NUCLEAR REGULATORY COMMISSION

Title: Advisory Committee on Reactor Safeguards

Date: Tuesday, November 1, 2022

ADVISORY COMMITTEE ON REACTOR SAFEGUARDS
(ACRS)

Staff Positions on ACRS DI&C Subcommittee Questions

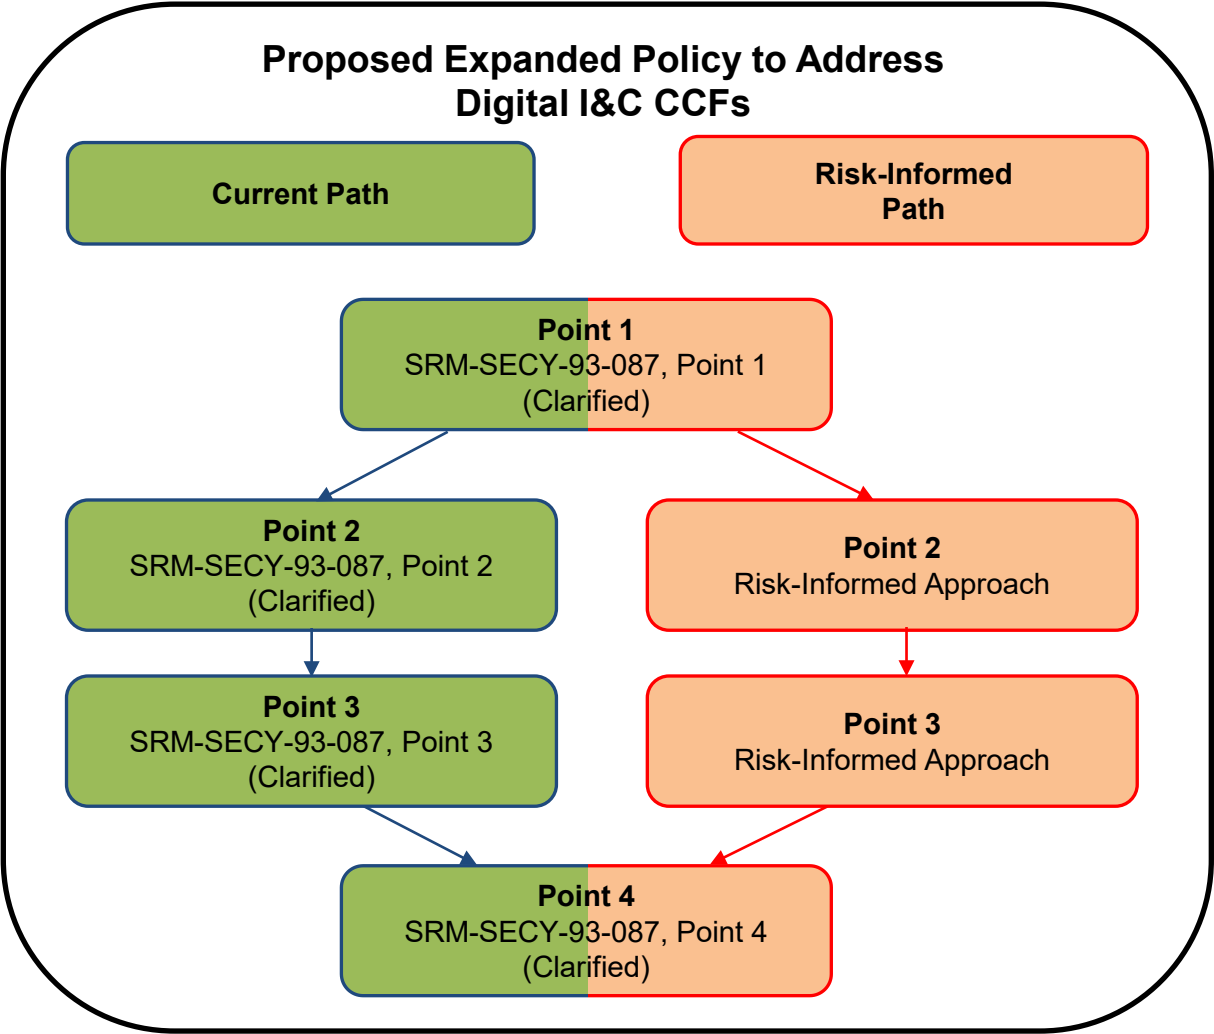
ACRS Question 1: *Would the revised policy be applicable to advanced reactors?*

ACRS Question 2: *Do aspects of the policy for which the staff did not request a change carry forward unaltered?*

ACRS Question 3: *Might different reactor types warrant consideration of different critical safety functions?*

Answer: The proposed expanded policy would apply to requests for all nuclear power plant types licensed under 10 CFR Part 50 and 10 CFR Part 52, including advanced reactors.

Answer: Yes

Answer: While the expansion of the policy is intended to be technology neutral it relies on the staff's licensing experience to date and assumptions about the design of the facility, such as the presence of a main control room. The staff acknowledges that the critical safety functions listed in the SECY and BTP 7-19 (reactivity control, core heat removal, reactor coolant inventory, containment isolation, and containment integrity) may not be the appropriate set for all reactor designs. The staff has existing regulatory tools (exemptions and alternatives), if necessary, to accommodate designs with different critical safety functions and, if the staff encounters a reactor design where the policy would not be applicable, the staff will engage the Commission as appropriate.

SECY-22-0076: Point 4 Commentary (contd.)

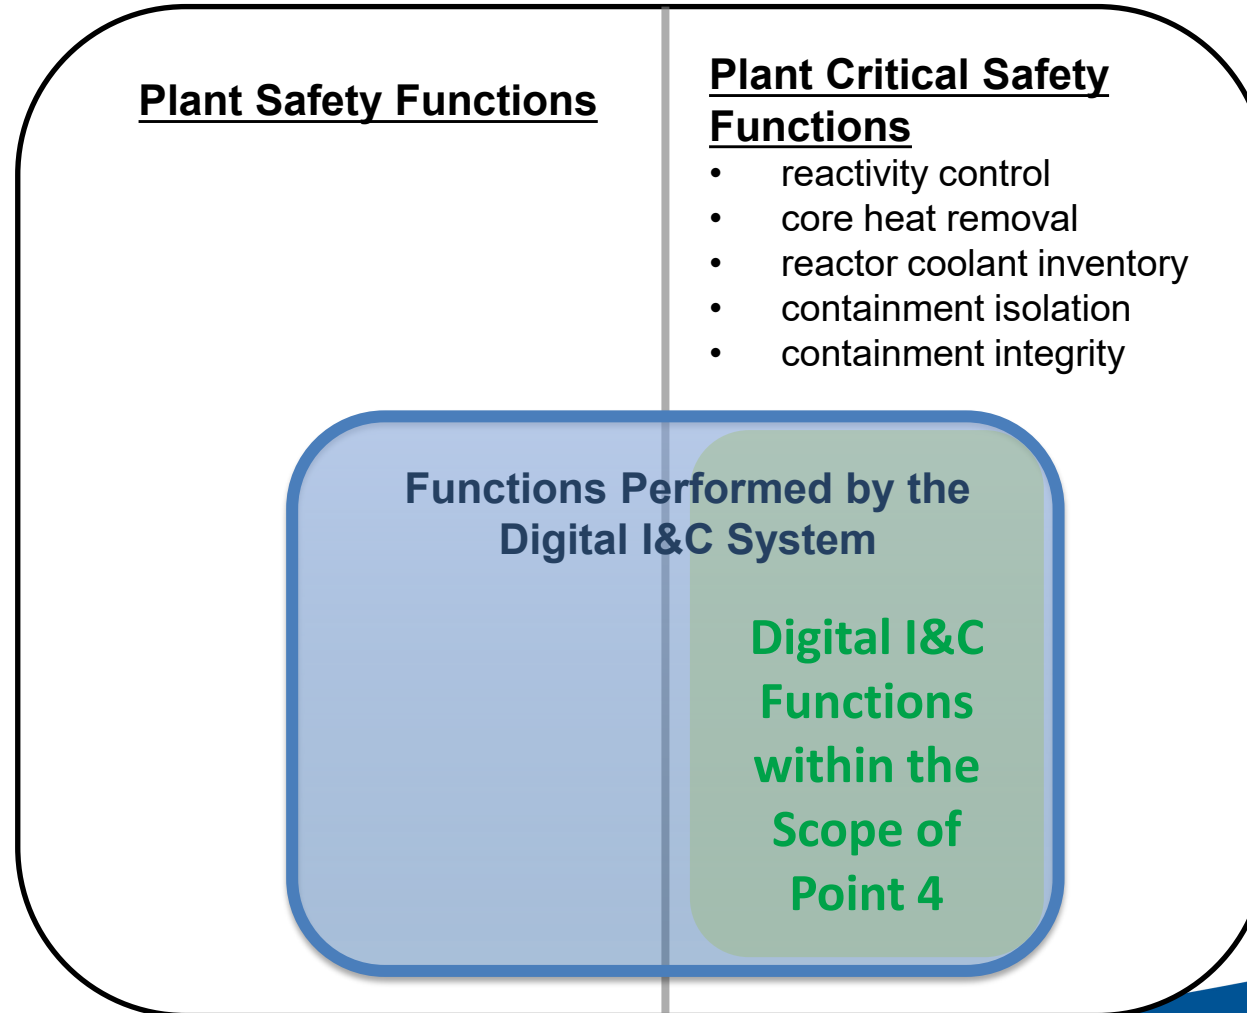
3 MR. DARBALI: But is that a comment
4 specific to the language in Point 4?

5 MEMBER MARCH-LEUBA: No, it's a comment
6 on your slide.

- The staff's position is that the digital I&C system should not be able to take control of the facility away from the operator under all plant conditions (anticipated or unanticipated)

- Point 4 already incorporates an implicit element of risk informing (in both SRM-SECY-93-087 and SECY-22-0076).
 - Point 4 is only applicable to critical safety functions (defined in SECY-93-087 and SECY-22-0076) and not to all the safety functions performed by the digital I&C system.

- The diverse displays and manual controls do not have to be safety-grade or hardwired.
